NEW RETAINING WALL

717 WALNUT STREET
PHILADELPHIA, PA 19103

Public comment -- 717 Walnut

On behalf of the Society Hill Civic Association's Zoning & Historic Preservation Committee, which has reviewed the application, I would like to provide some comments for the Architects Committee's consideration:

3 SECTION @ EXTERIOR CONCRETE STAIRS
A-1.0 SCALE: 3/8" = 1'-0"

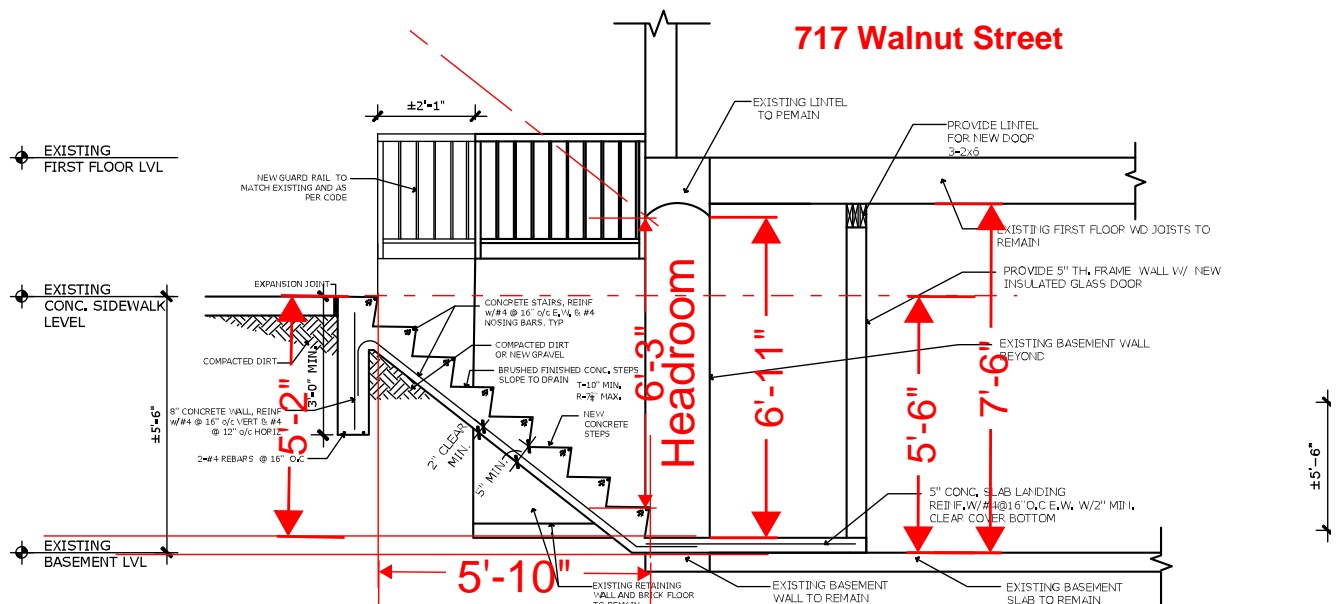
Code requires Risers of 7" max for egress, these are 7.75" and exceed code. Nose of bottom step to lintel has less than 6'-8" headroom required. Treads are shown as 10", but code requires 11" minimum.

Existing grating appears to be in the area at the top of the proposed stairs. There may be a void under sidewalk or steam line?
